DONALD C. COOK NUCLEAR PLANT UNIT NO. 1

AMENDMENT TO FACILITY OPERATING LICENSE

Amendment No. 33  
License No. DPR-58

SAFETY EVALUATION BY THE OFFICE OF NUCLEAR REACTOR REGULATION  
RELATED TO AMENDMENT NO. 33 TO FACILITY OPERATING LICENSE NO. DPR-58  
AND AMENDMENT NO. 14 TO FACILITY OPERATING LICENSE NO. DPR-74

FIGURE 6.2.1 Offsite Organization for Facility Management and Technical Support

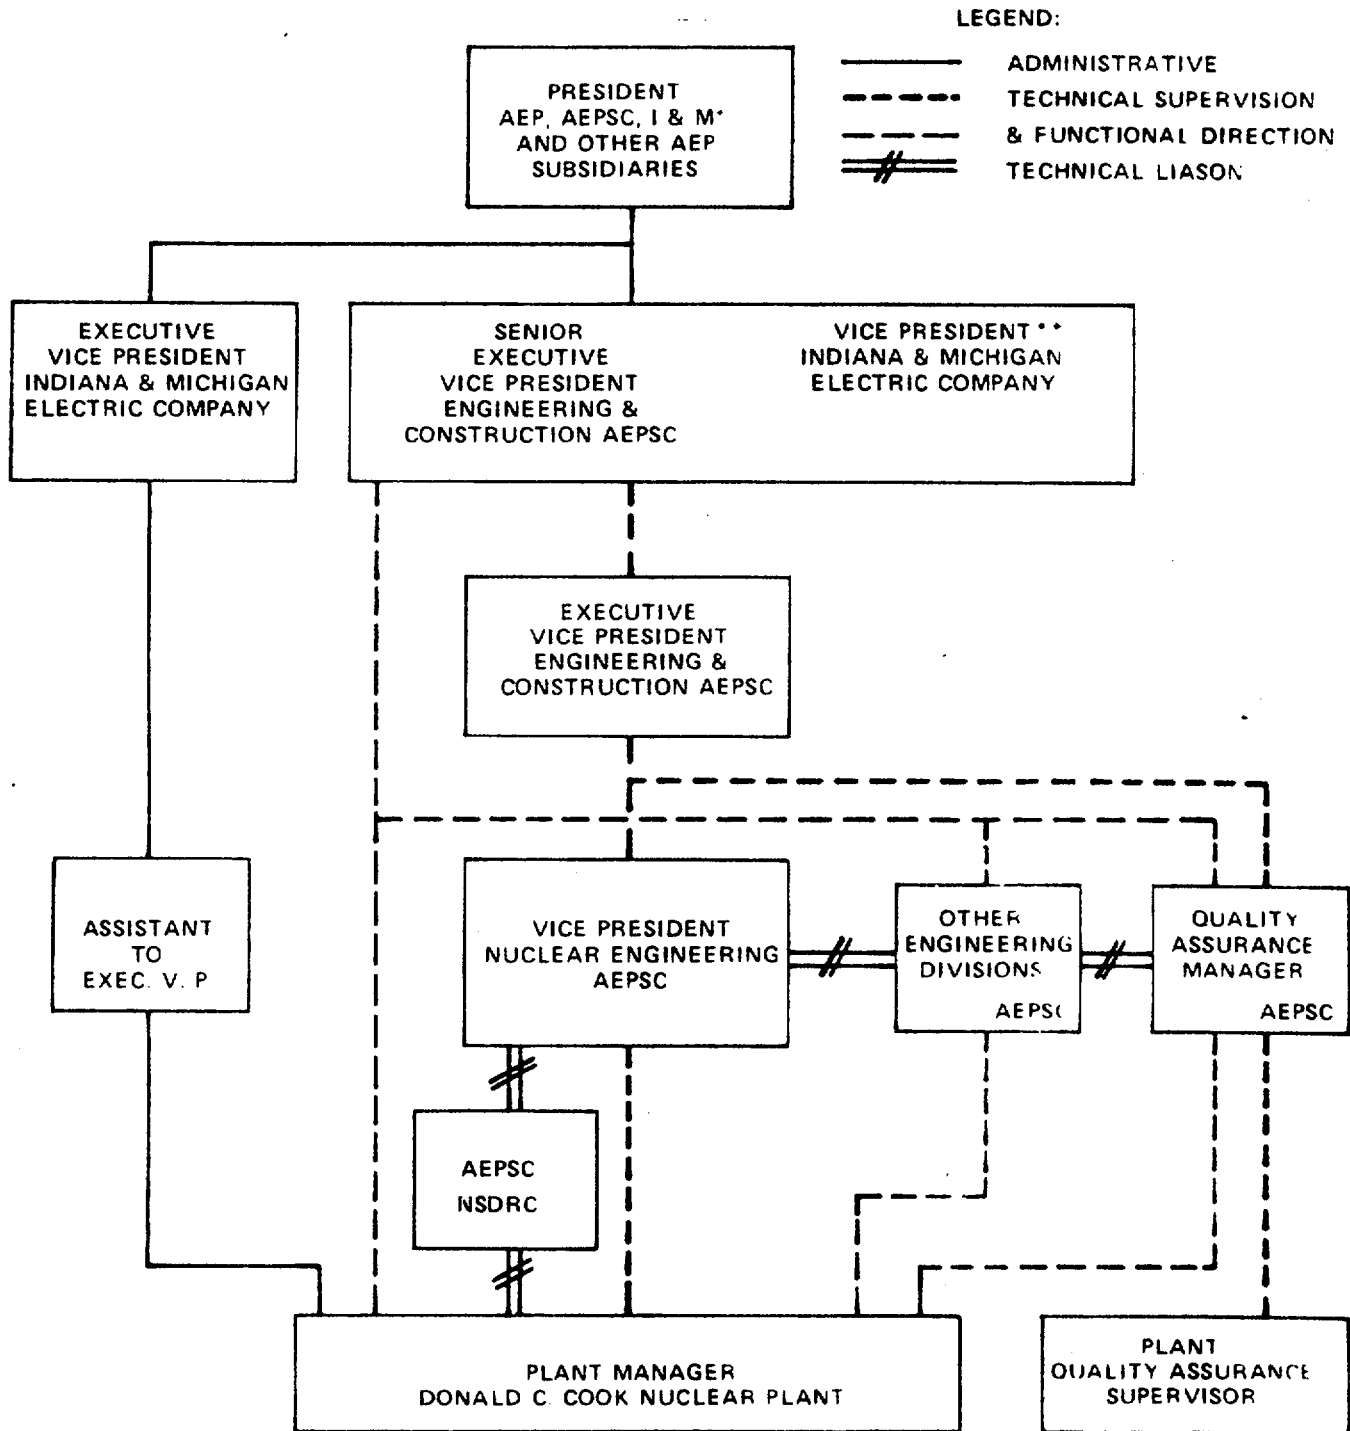
Replace the following pages of the Appendix "A" Technical Specifications with the enclosed pages. The revised pages are identified by Amendment number and contain vertical lines indicating the area of change. The corresponding overleaf pages are also provided for document completeness.

In addition to the merger, the licensees brought to our attention certain title changes within their organizations. We have taken this opportunity to correct the Administrative Controls area of the Technical Specifications. These changes in titles will have no effect on the continued safe operation of the D. C. Cook Nuclear Plant.

FIGURE 6.2-1 Offsite Organization for Facility Management and Technical Support

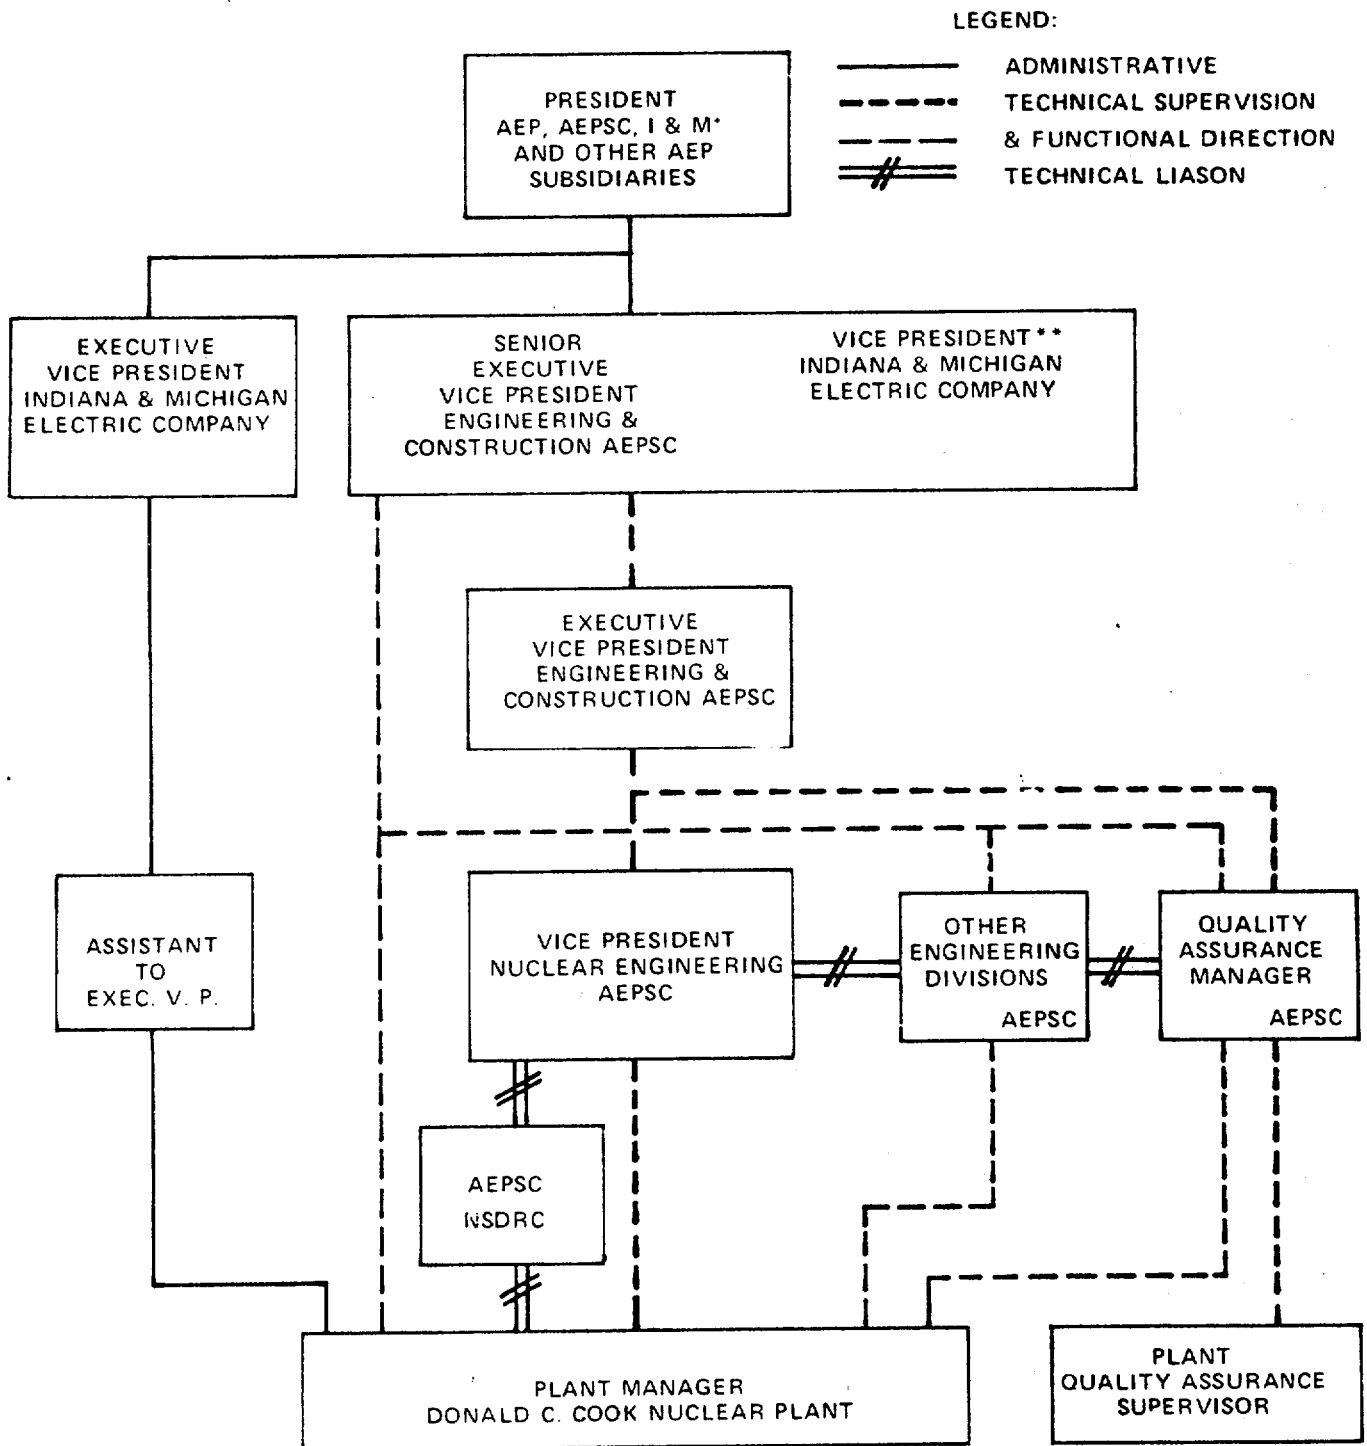
Replace the following pages of the Appendix "A" Technical Specifications with the enclosed pages. The revised pages are identified by Amendment number of contain vertical lines indicating the area of change. The corresponding overleaf pages are also provided to maintain document completeness.
